G.A.V. & ASSOCIATES, INC.
 DIMENSION AND LAYOUT PLAN
 2260 CROOKS ROAD - PARCEL NO. 15-29-276-001
 SECTION: 29
 CITY OF ROCHESTER HILLS
 OAKLAND COUNTY
 MICHIGAN

J2023-0144
 PSP2024-0037
 Revision #1
 Received 1/8/2025
 City of Rochester Hills
 Planning & Economic
 Development

site plan.pdf Markup Summary

G.A.V. ASSOCIATES, INC
2401 ORCHARD LAKE RD. STE. 100A
FARMINGTON, MICHIGAN 48338
PH: (248) 985-9101
WEB: WWW.GAVASSOCIATES.COM

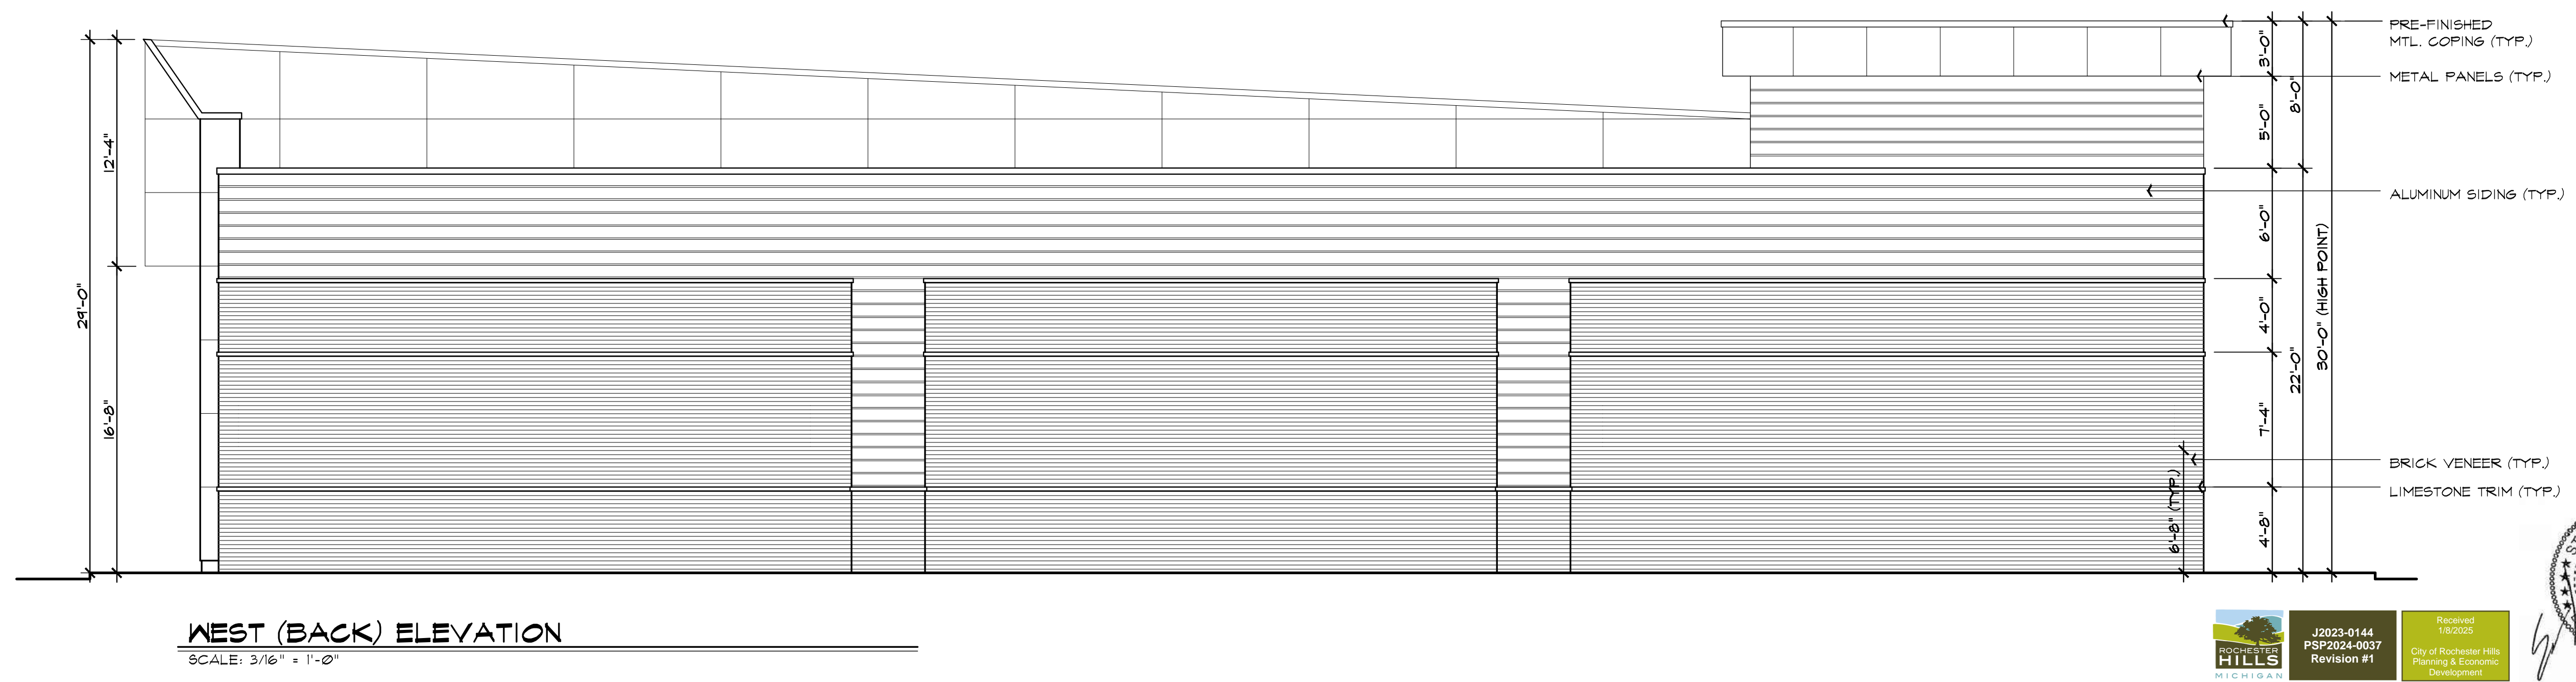
Planning Commission to review proposed building material type and allocation along with overall building architectural design.
